**COMBUSTION ENGINEERING**

Subject: License Amendment Request for R-2 Modifications

**LICENSE AMENDMENT REQUEST**

Combustion Engineering requests that the license (SNM-33) for its Hematite Nuclear Fuel Manufacturing Facility be amended to reflect changes which will be made to the  $UF_6$  to  $UO_2$  conversion line. In brief, this modification involves the addition of a new section to the upper end of the R-2 reactor. This new section is of a larger diameter and extends R-2 to a height of eleven feet four inches. This modification of R-2 will reduce carryover, minimize recycle and reduce material handling.

Figure II.9-2

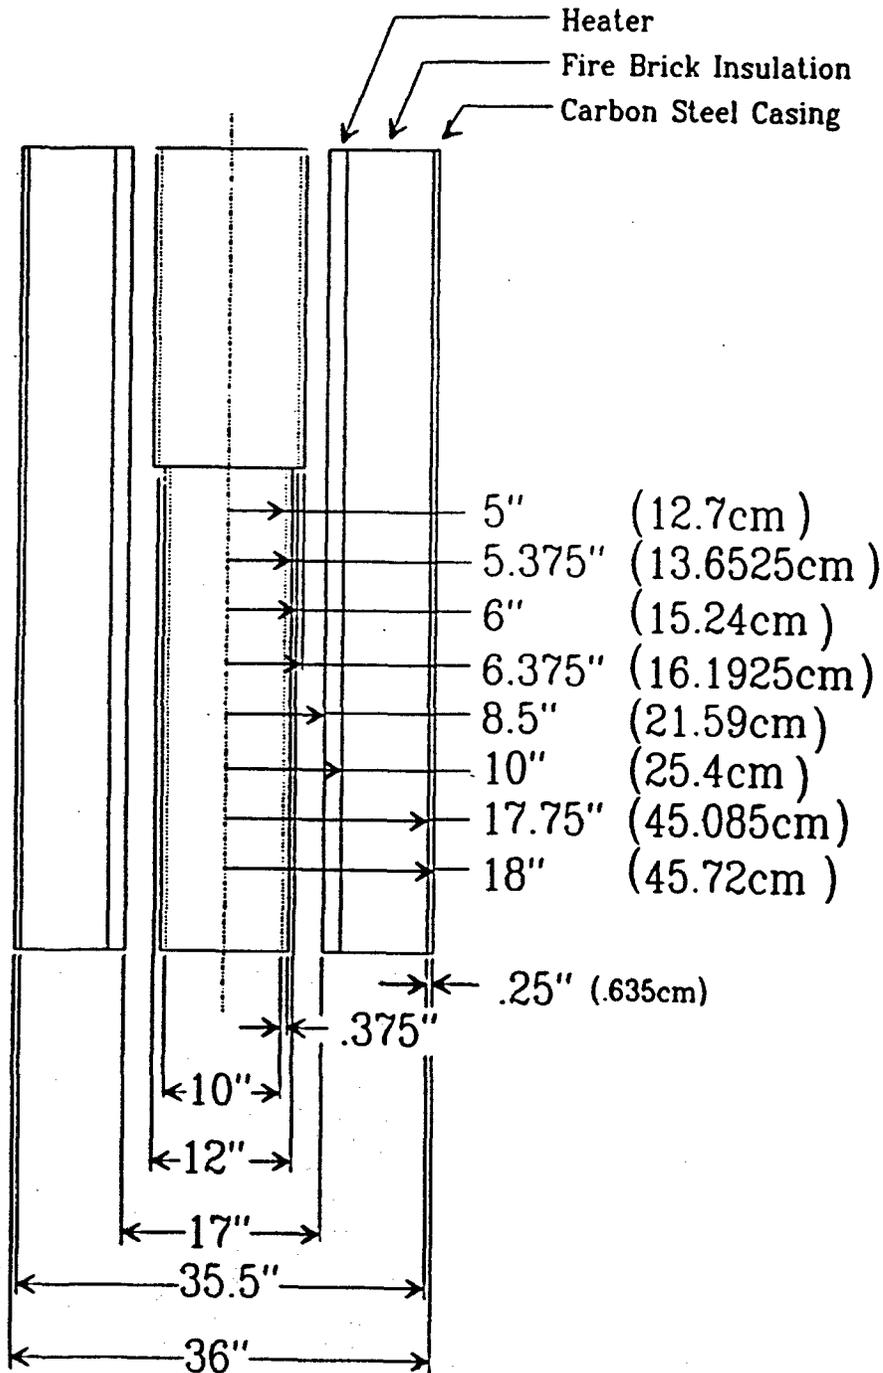
Vessel R-2 and it's furnace are shown in cross-section on Figure 9-2. For comparison, the upper end configuration of vessels R-1 and R-3 are shown in dotted lines. The elevation view of the UF<sub>6</sub>-UO<sub>2</sub> conversion reactor line is shown on Figure 9-1.

The lower sections (10" diameter and 12" diameter) are the same for all three vessels. Vessel R-2, however, has an additional 16" diameter section which increases the total height to 11'4".

- 1) Maximum enrichment 5.0%.
- 2) Under process design (normal) conditions, SNM is only in the 10" diameter lower section of the vessel.
- 3) Reflection as provided by furnace insulation; and vessel steel walls as shown in Figure II.9-2.

- a) Reactors R-1 and R-2 were assumed to be filled in the 10" portion (i.e., no overflow) with dry  $\text{UO}_2$  at 2.5 g/cc density of powder and 5.0 w/o  $\text{U}^{235}$ . All structures consisting of .375" steel wall, 7.75" of 37.5 lbs/ft<sup>3</sup> firebrick insulation and .25" steel casing were included in the model. The conservative reactor details shown in Figure II.9-2 (page II.9-4) were used.

Figure II.9-3

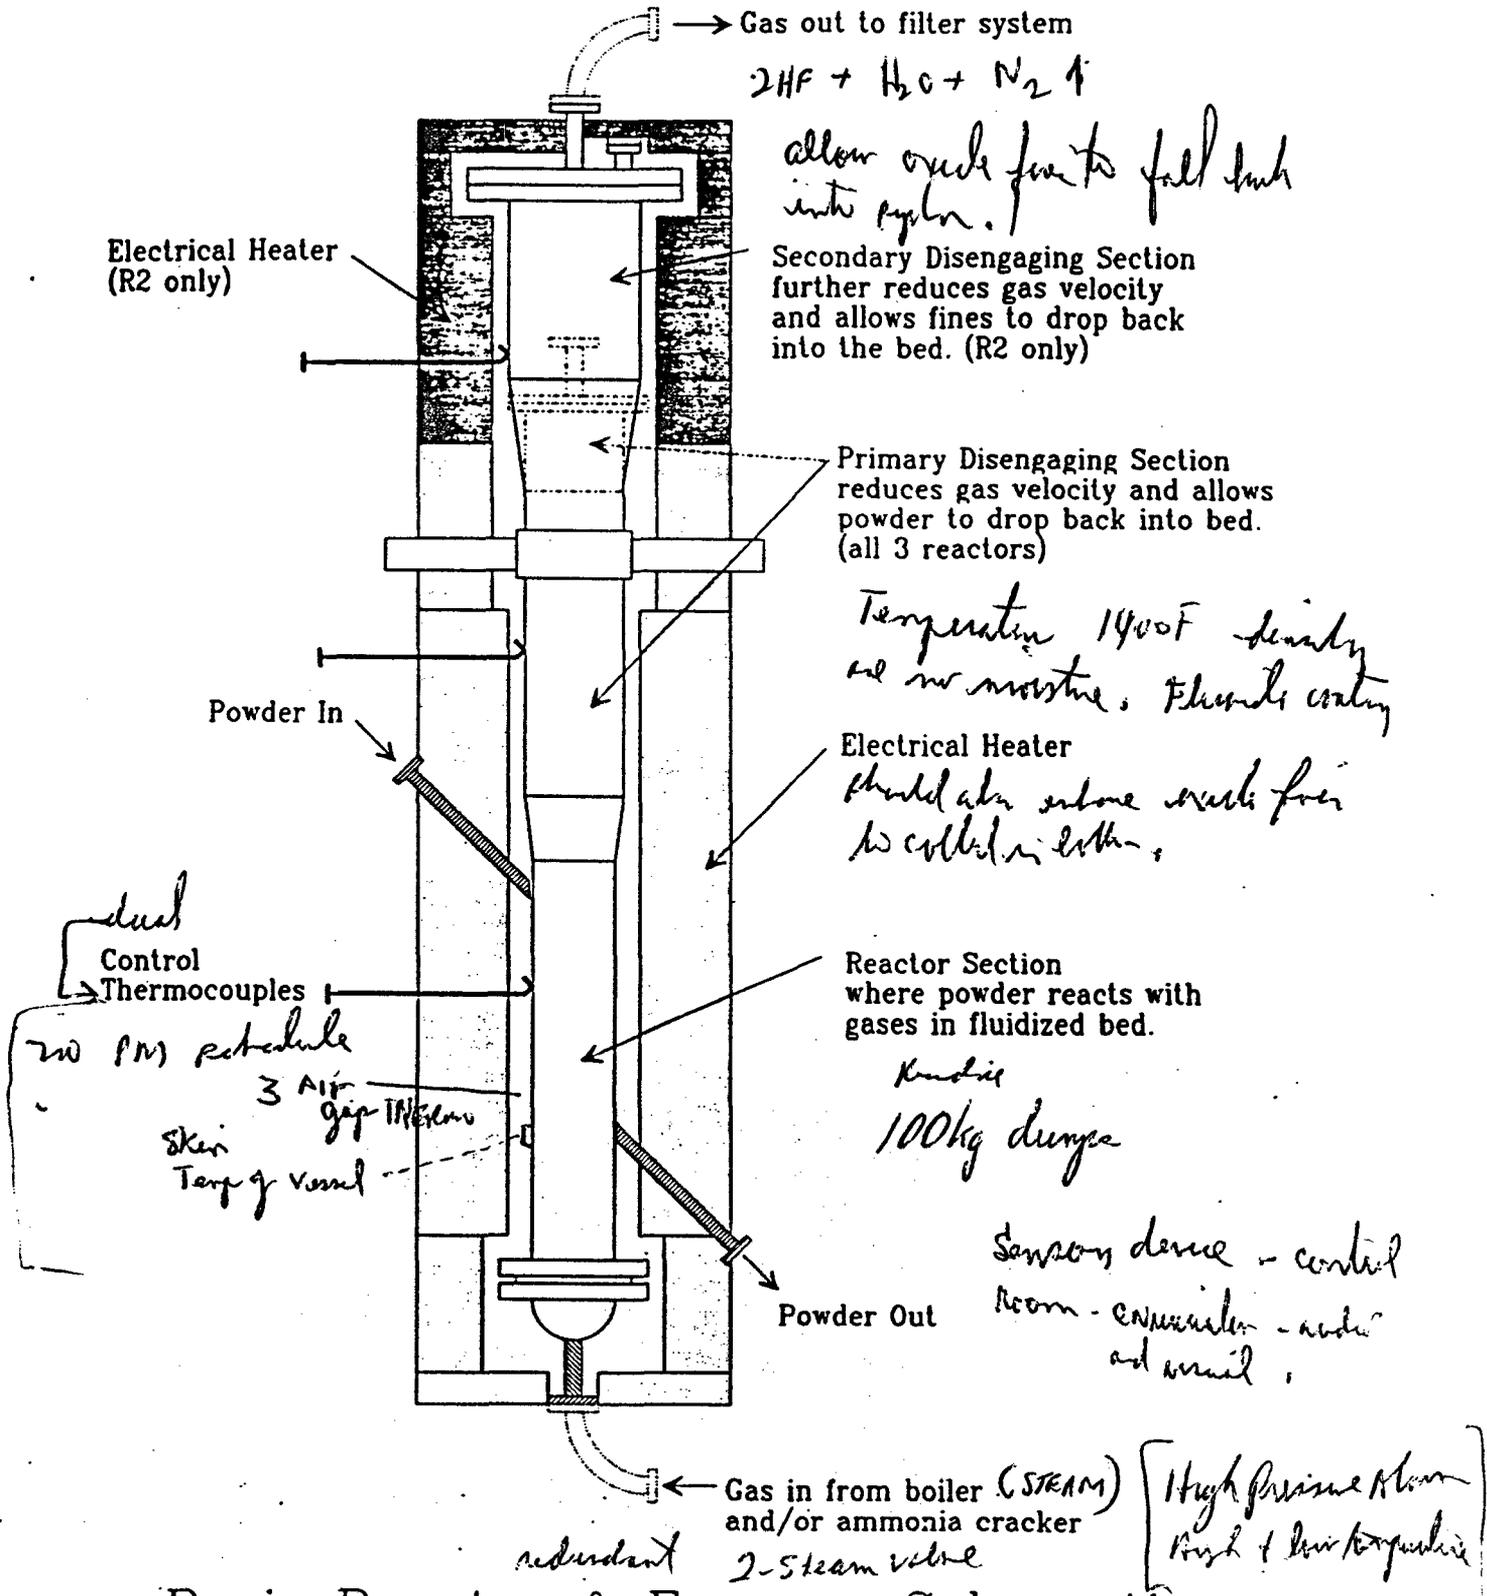
All three vessels are fitted with electrically heated furnaces. R-1 and R-3 have two independently controlled sections and R-2 has three independently controlled sections. All three reactors have low temperature alarm set points and R-2 has a second (redundant) low temperature alarm setpoint. In addition, the steam supply line to R-2 has two shut-off valves (one redundant) which are activated by the low temperature alarm setpoints from the R-2 controllers.
